APPENDIX 137

UNITIZATION PROCEDURES FOR BOXED AMMUNITION AND COMPONENTS ON 4-WAY ENTRY PALLETS

DELAY ELEMENT, DETONATING, PACKED 200 PER
WOODEN BOX, UNITIZED 9 BOXES PER 40" X 48"
PALLET; APPROX BOX SIZE $33\frac{7}{8}$ " L X $14\frac{3}{8}$ " W X $15\frac{7}{8}$ " H

REVISION NO. 1, DATED DECEMBER 1986, CONSISTS OF:

PALLET UNIT

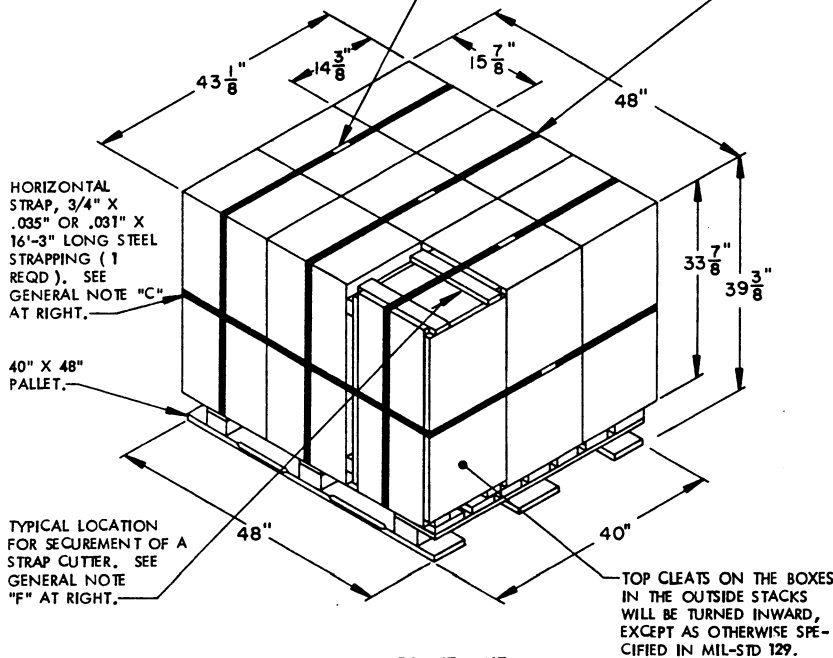
1. CHANGING BOX DIMENSIONS
2. UPDATING PALLET UNIT TO CONFORM TO 1. ABOVE.
